7.6 All Other Instrumentation Systems Required for Safety

The information in this section of the reference ABWR DCD, including all subsections, tables, and figures, is incorporated by reference with the following departures and supplements.

Figure 7.6-4a Basic Configuration of a Typical Neutron Monitoring System Division

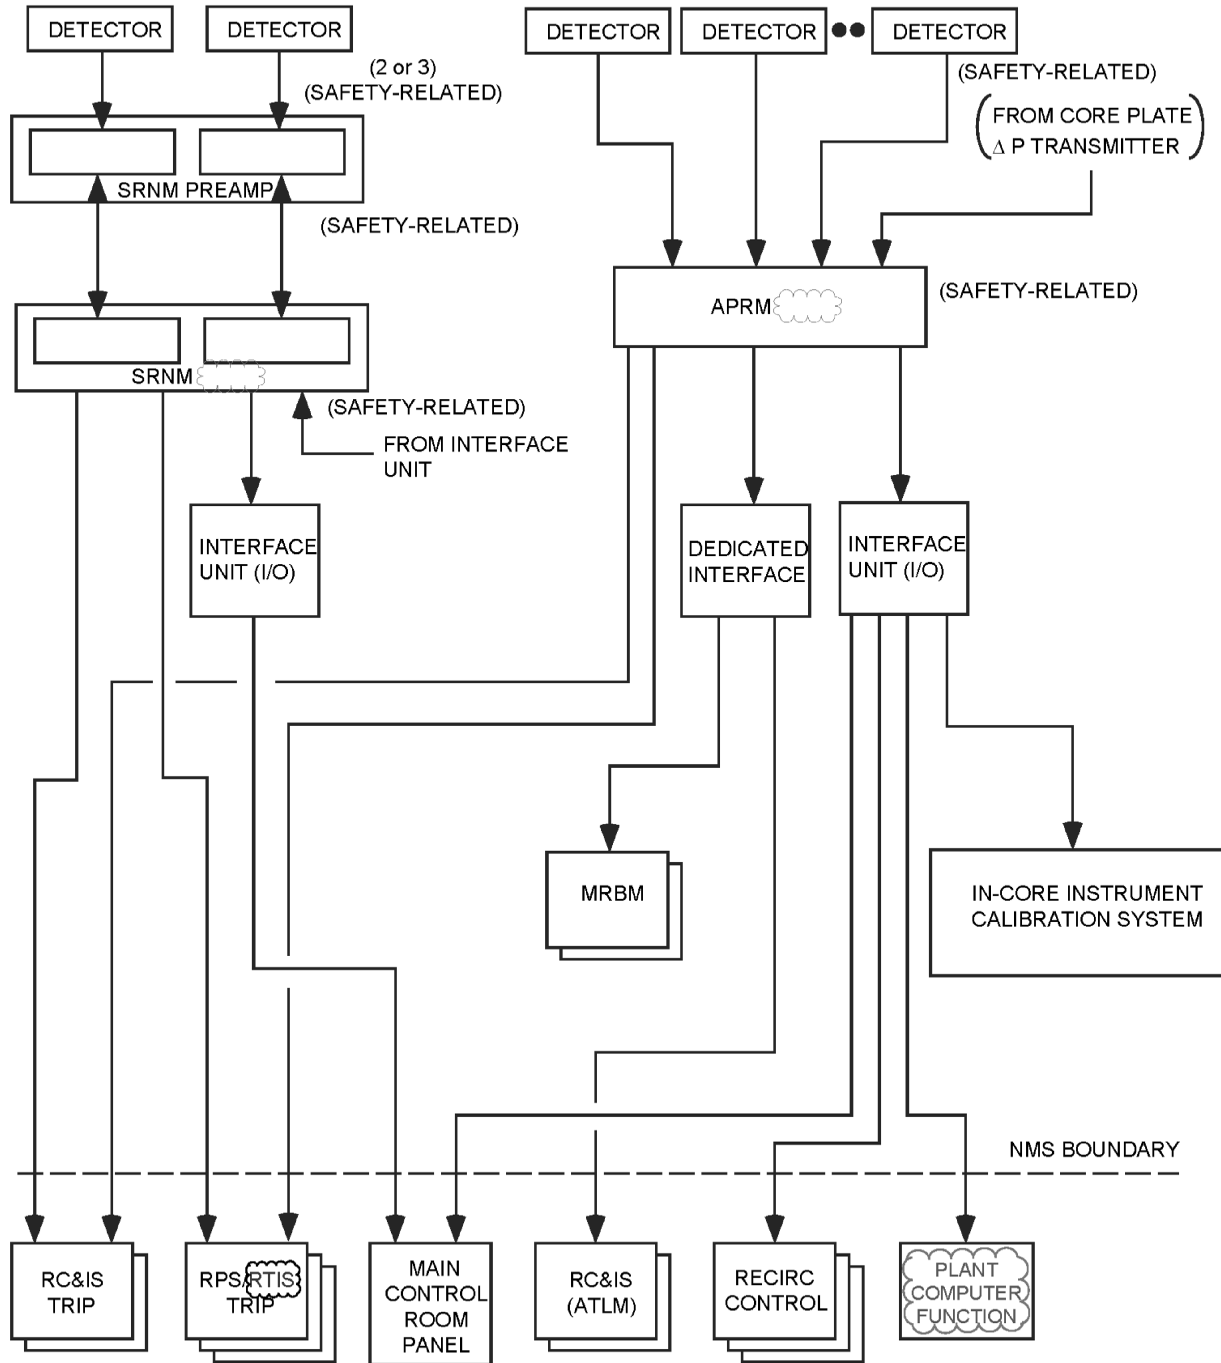
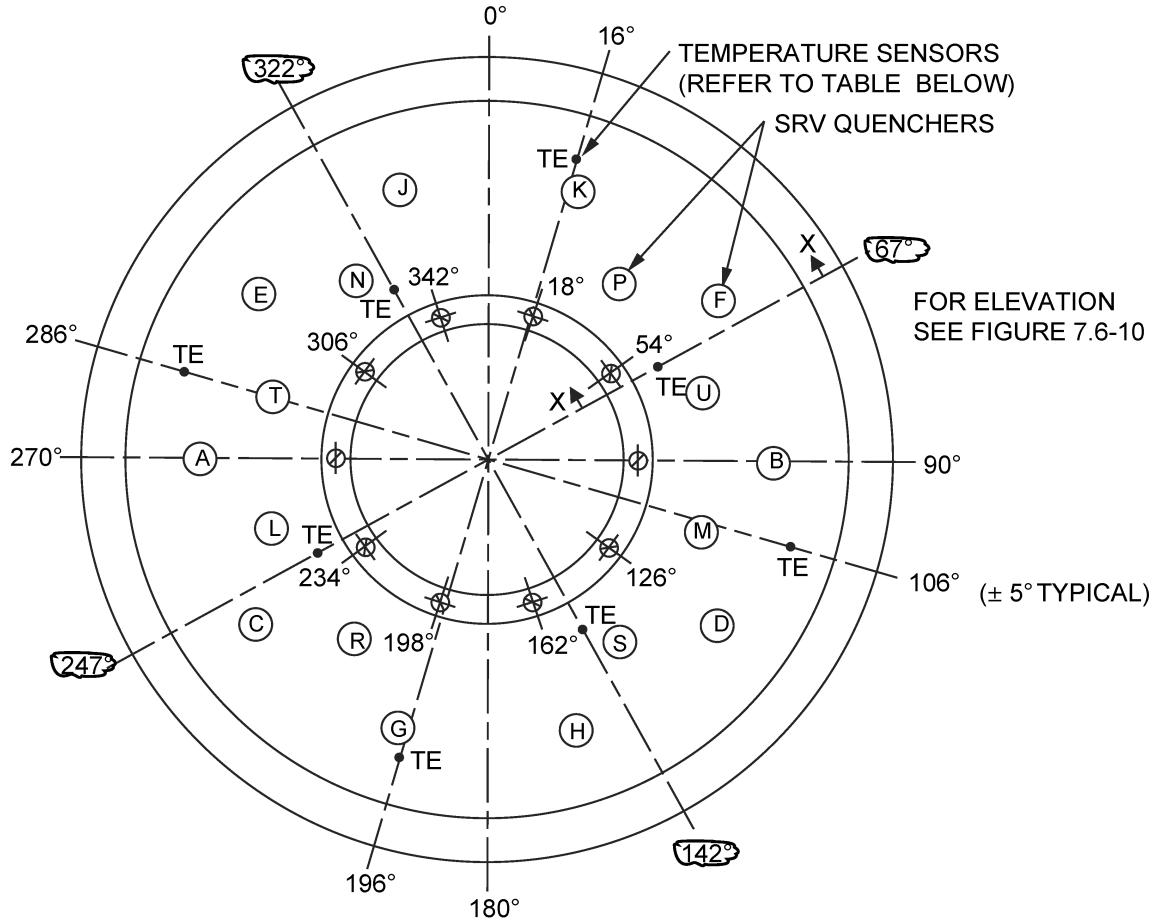
STD DEP T1 3.4-1 (Table 7.6-5 and Figures 7.6-1, 7.6-2, 7.6-4a)

The purpose of the Neutron Monitoring System (NMS) is to monitor power generation and, for the safety function part of the NMS, to provide trip signals to the Reactor Protection System (RPS) to initiate reactor scram under excessive neutron flux (and power) increase condition (high level) or neutron flux fast rising (short period) condition. The NMS also provides power information of operation and control of the reactor to the Plant Process Computer System (PCS) Functions (PCF) and the rod block monitor. A block diagram showing a typical NMS division is shown in Figure 7.6-4a. The operating ranges of the various detectors are shown in Figure 7.6-4b.

Figure 7.6-9 Instrumentation Location Definition for the Suppression Pool Temperature Monitoring System

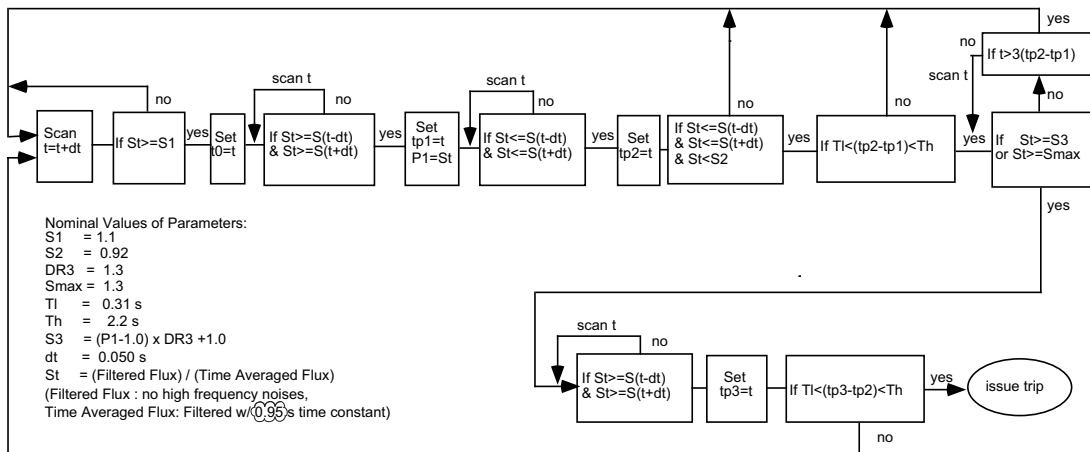
STD DEP 7.6-3 (Figures 7.6-9, 7.6-11)

The SPTM System configuration is shown in Figures 7.6-9 and 7.6-10. There are eight temperature circumferential sensor locations (Figure 7.6-9), which are chosen based upon the following considerations:

- (2) *Each SRV discharge line quencher is in direct sight of two sets of temperature sensors within 9 meters.*

Figure 7.6-14 OPRM Logic

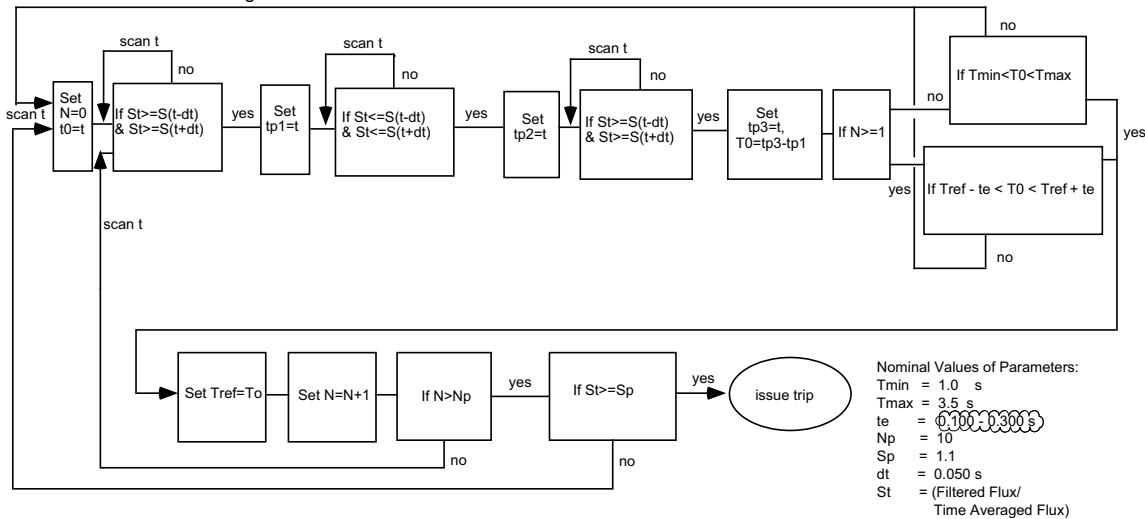
STD DEP 7.6-1 (Table 7.6-2 and Figures 7.6-2, 7.6-14)

~~For the OPRM trip function, the response signal of any one OPRM cell that satisfies the conditions and criteria of the trip algorithm will cause a trip of the associated OPRM channel. Figure 7.6-14 illustrates the trip algorithm logic. The OPRM trip function does not have its own inoperative trip for insufficient number of total LPRM inputs in the channel. It follows the APRM's inoperative trip of insufficient number of LPRMs.~~ The OPRM function has its own inoperative trip when the channel has less than the required minimum operable cells, when there is an OPRM self-diagnostic fault, when the APRM instrument watchdog timer has timed out, or if there is a loss of power to the APRM instrument.

$T_{\min}=1$ s, $T_{\max}=3.5$ s, $\pm t_{\text{error}}=0.15$ s **[0.100 - 0.300s]**, $N_P=10$.
 (For details see Figure 7.6-14).
